Economic Commission for Europe**Inland Transport Committee****World Forum for Harmonization of Vehicle Regulations****Working Party on General Safety Provisions****116th session**

UN Regulation No. 35 (Foot controls)**Proposal for the 01 series of amendments to UN Regulation
No. 35 (Foot controls)****Submitted by the expert from the International Organization of Motor
Vehicle Manufacturers***

The text reproduced below was prepared by the expert from the International Organization of Motor Vehicle Manufacturers (OICA) to clarify the measurement method of the lateral distance of the pedals to the nearest "wall" to the left. It is based on informal document GRSG-115-17, presented at the 115th session of the Working Party on General Safety Provisions (GRSG) (see report ECE/TRANS/WP.29/GRSG/94, para. 14). The modifications to the current text of UN Regulation No. 35 are marked in bold characters.

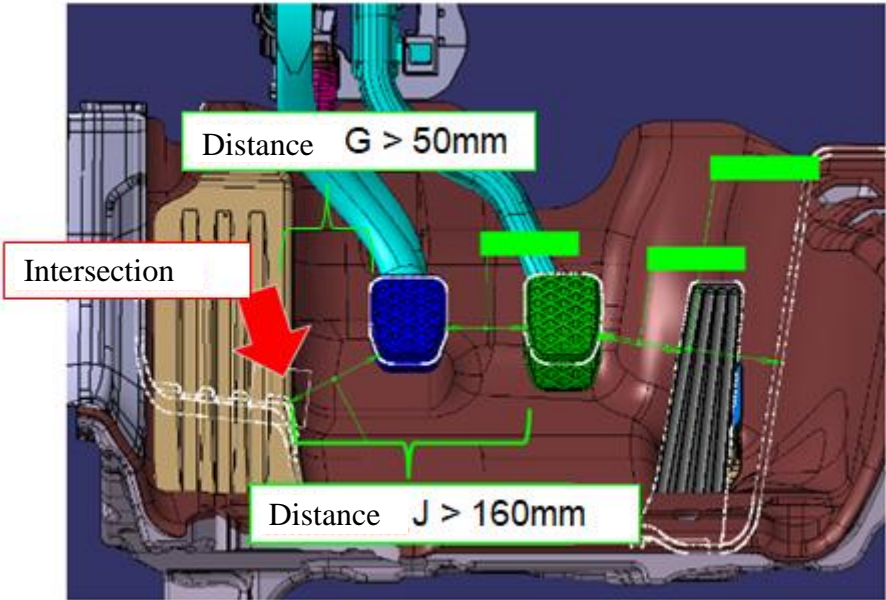
Paragraph 5.7., amend to read:

"5.7. The distances, respectively shown as "H" and "J" in Annex 4, between the projection of the service-brake pedal on to the reference plane "P" and the intersection of each of the walls with that plane shall be ≥ 130 mm to the right and ≥ 160 mm to the left for vehicles with three pedals, and ≥ 130 mm to the right and ≥ 120 mm to the left for vehicles with two pedals.

In case of a foot rest as declared by the manufacturer, installed for the driver's left foot, the shortest distance between the most left pedal and the wall shall be measured above the foot rest, and the minimum distance between the projection of the most left pedal and that foot rest on to the reference plane "P" shall be ≥ 50 mm."

Three pedals – Conventional transmission

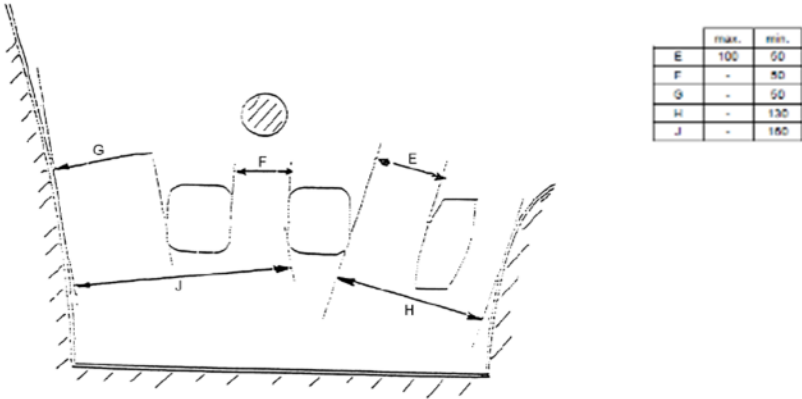
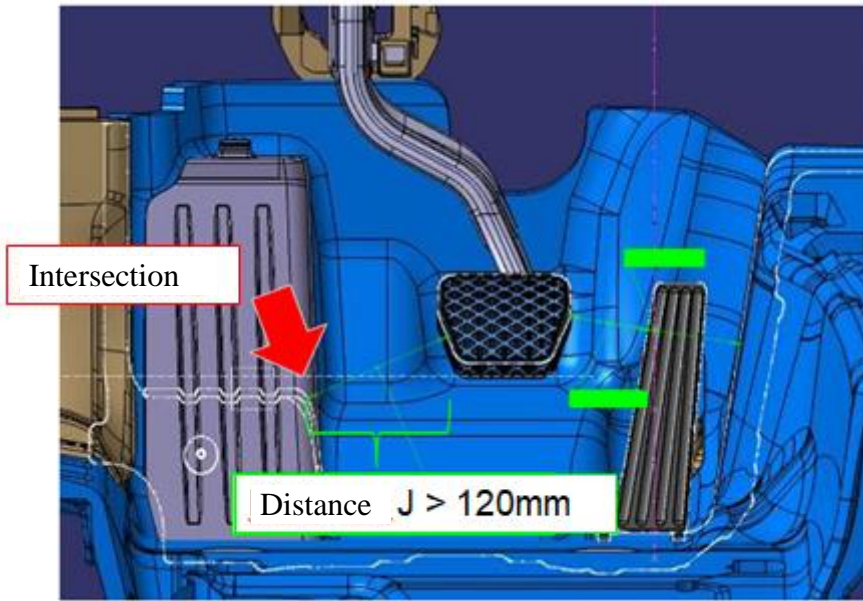
2. This proposal hence clarifies the measurement method for the lateral distances of the pedals to the nearest "wall" to the left. For safety and comfort reasons foot rests are installed for the drivers' left foot. The rest plane of such foot rests can intersect the measurement plane "P". This proposal clarifies that, in such cases, the required clearance for the left foot is measured on top of the foot rest, rather than between the left most pedal and the foot rest itself.

- 3. To ensure clearance of travel for the left most pedal (either service brake or clutch), an additional minimum distance between this pedal and the foot rest is introduced.
- 4. The proposal is introduced as a new series of amendments because it may add new constraints to some manufacturers.
